**REQUEST FOR TENDER No. 21-025**

**Sludge Storage Cell 3 Replacement**

**Addendum 2**

<b>REGIONAL DISTRICT OF NANAIMO</b>	<i>Request for Tenders No. 21-025</i> <b>Sludge Storage Cell 3 Replacement</b> <u><b>Addenda-2</b></u>	Date: March 31, 2021 Revision: 0
---	--	-------------------------------------

TOLERANCES (U.N.O.)		
LINEAR	ANGULAR	
X ± 1.5	X.X ± 1/2°

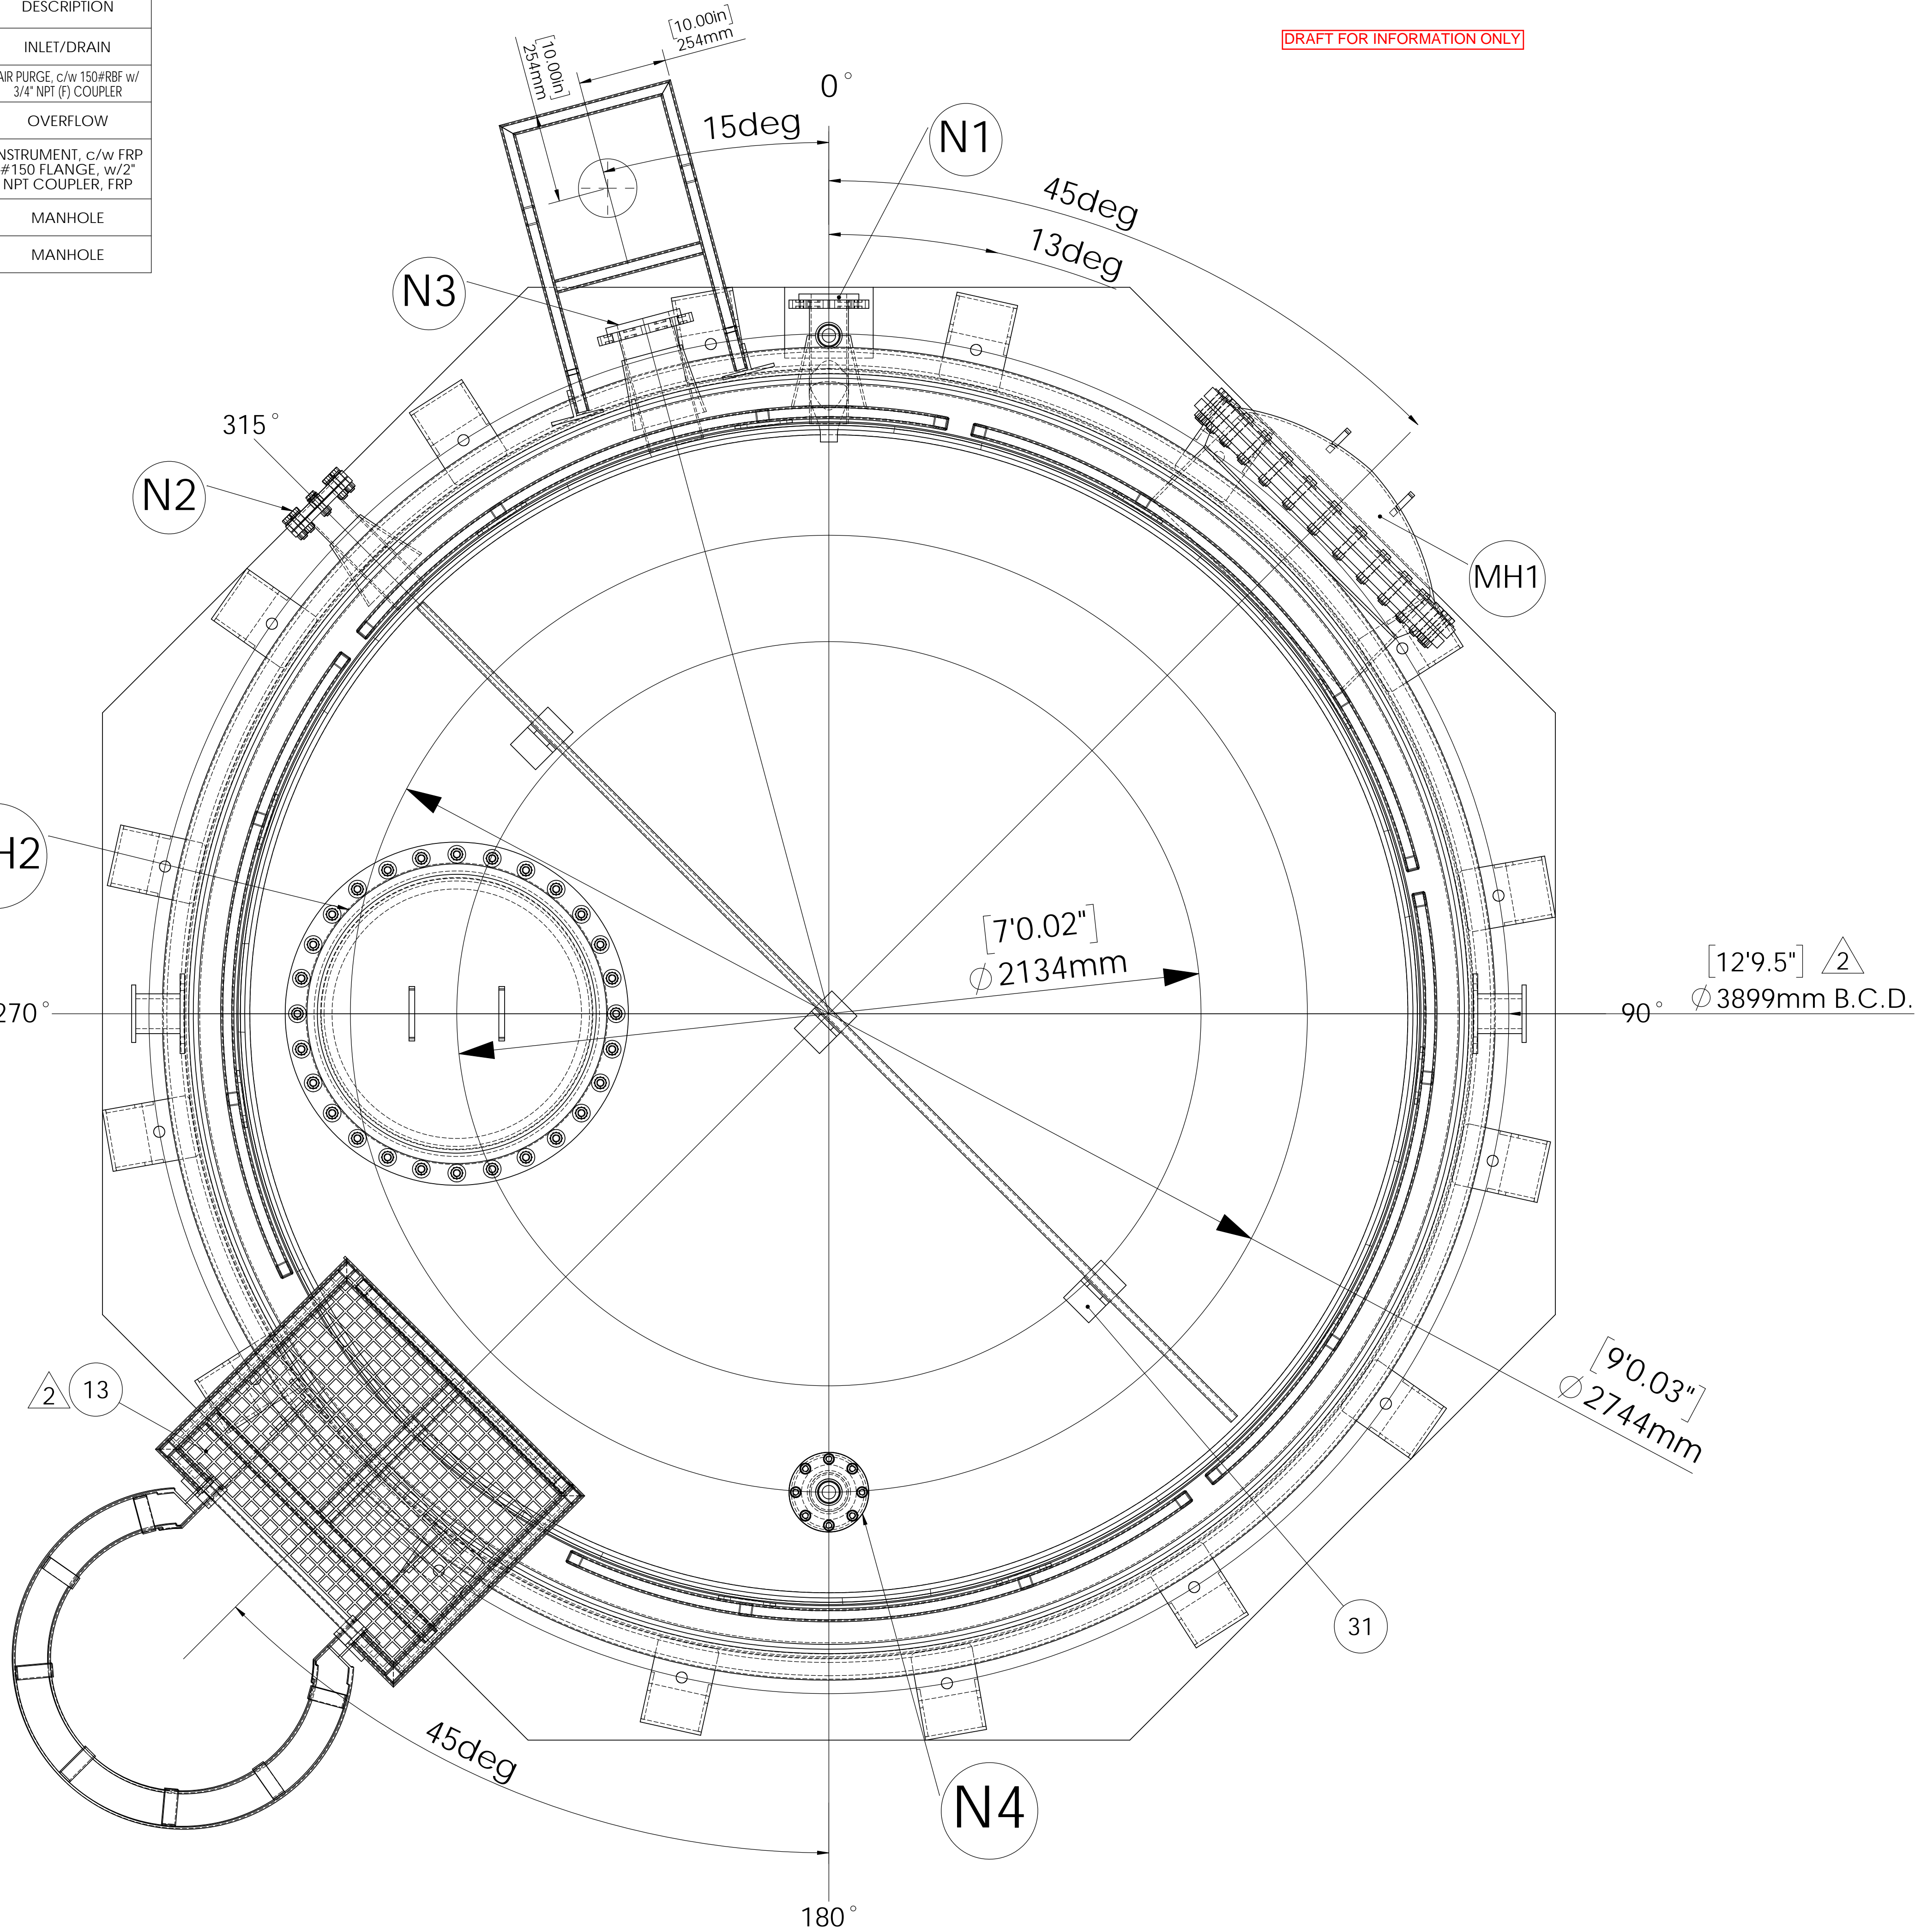
1. **Note** – The tender closing date is revised from Friday April 16, 2021 to **Friday April 23, 2021**.
2. **Note** – Please refer to the attached draft sludge storage cell 3 shop drawings from the FRP tank fabricator. These are provided for information only. Final approved shop drawings will be provided to the successful bidder upon award.

18. **Question:** Will the tank fabricator be supplying a bolting template/layout or will the tank be shipped to site and we will have to provide or own?

19. **Question:** Where are the new tank lifting lugs located?

**Answer:** *The tank fabricator will not be supplying an anchor bolt template. The clamp bracket anchoring design is conceived to allow for minor deviations in anchor bolt location. Please refer to the tank fabricator's draft shop drawings for additional information. The Contractor remains responsible for meeting the anchor bolt tolerances necessary for installation of the tank as per the Drawings.*

**Answer:** *Please refer to the tank fabricator's draft shop drawings for lifting trunnion locations. The lift must be completed using a spreader bar on the main crane line and a tail crane connected to the tank bottom with a long webbing choker sling.*

PRECAST CONCRETE BULL-NOSE  
**460 mm** – CBN-H & CBN-E

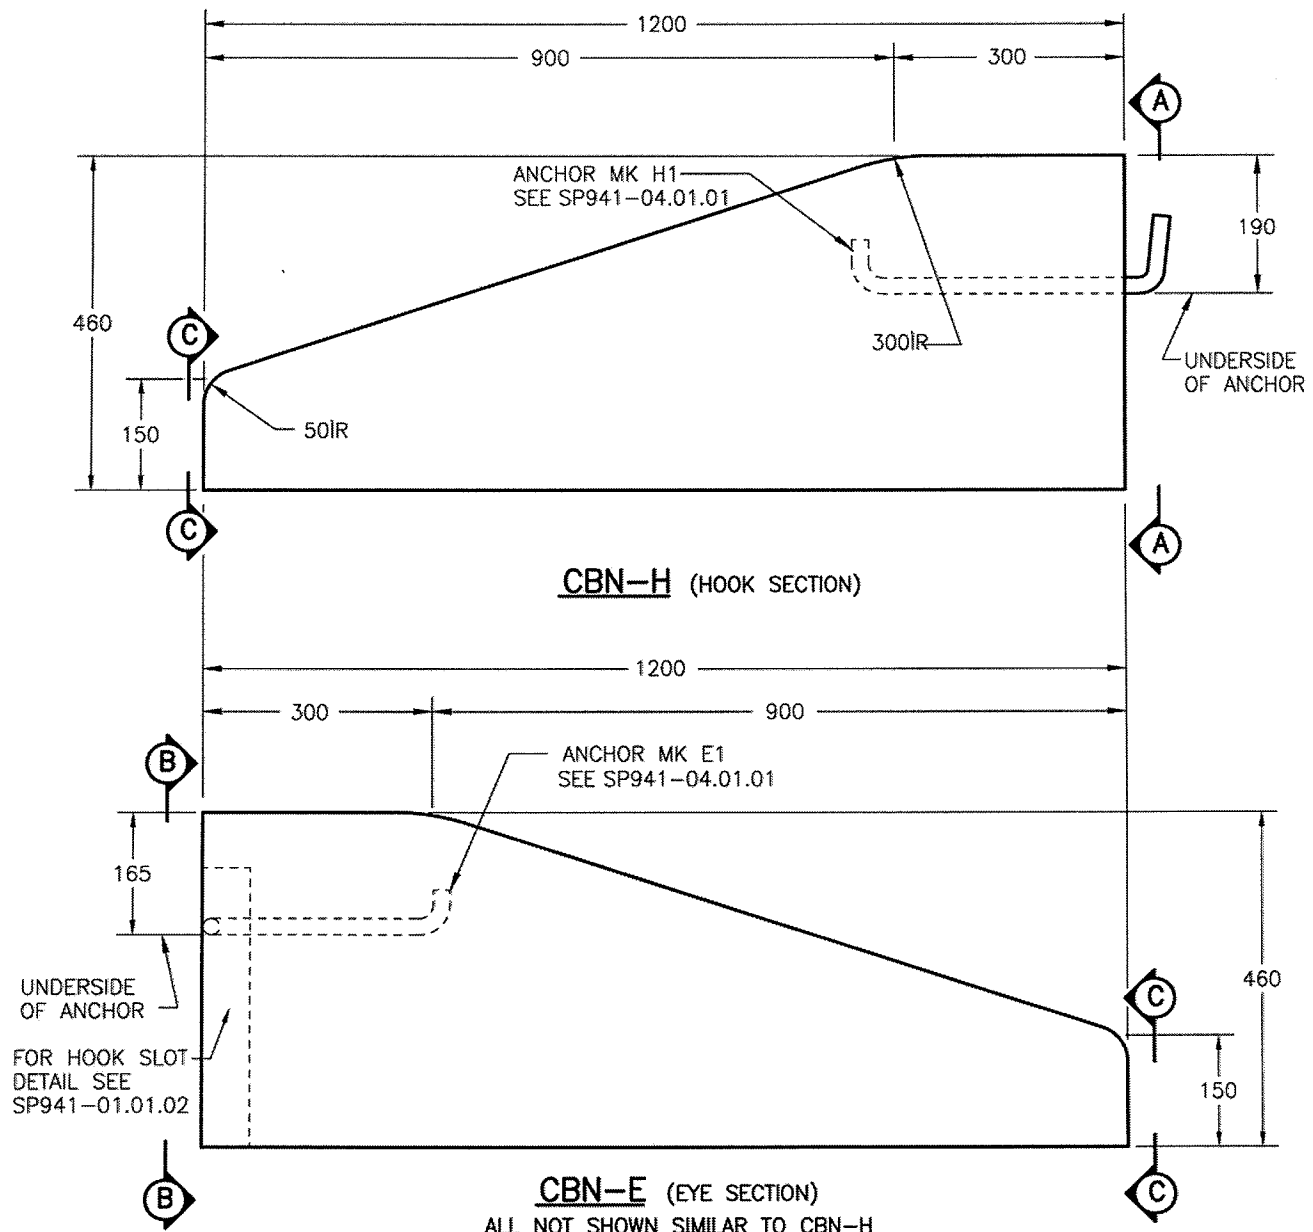
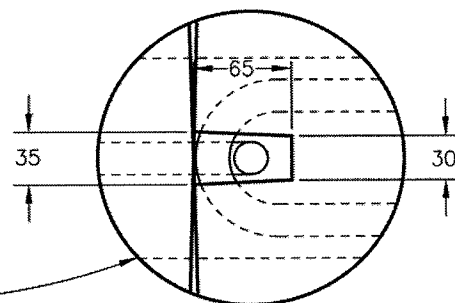
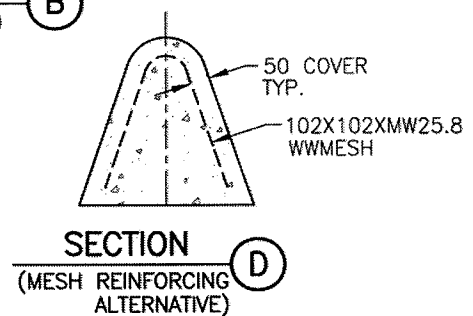
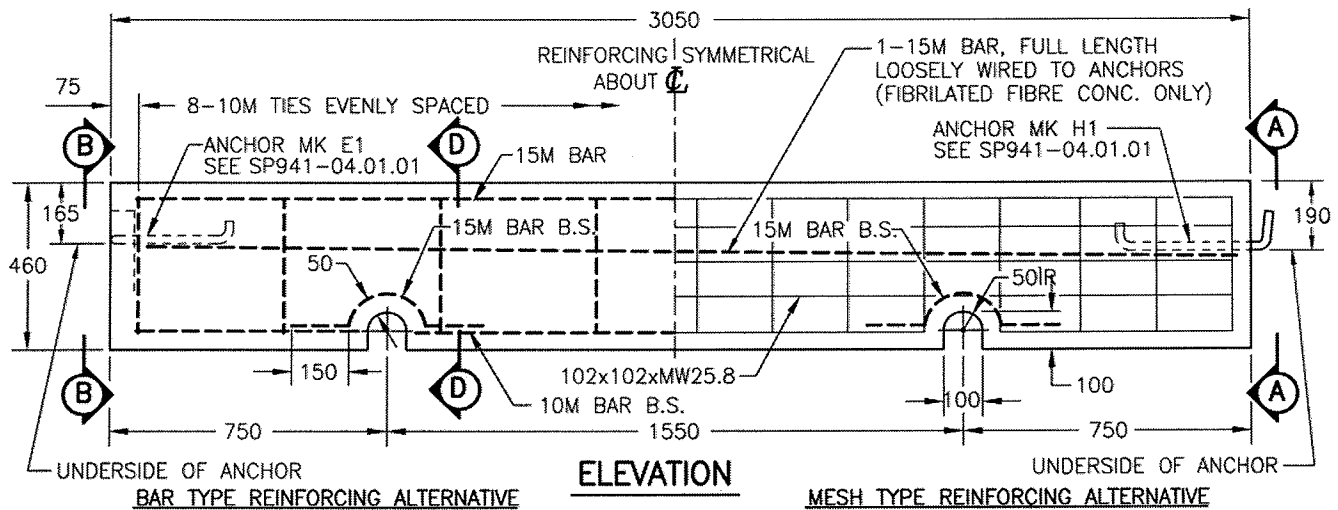
16. **Question:** What size of concrete barrier and bull nose barrier would you like installed as shown on drawing FC-M-311?

**Answer:** *The design has assumed 460 mm barriers as per attached MOT standard.*
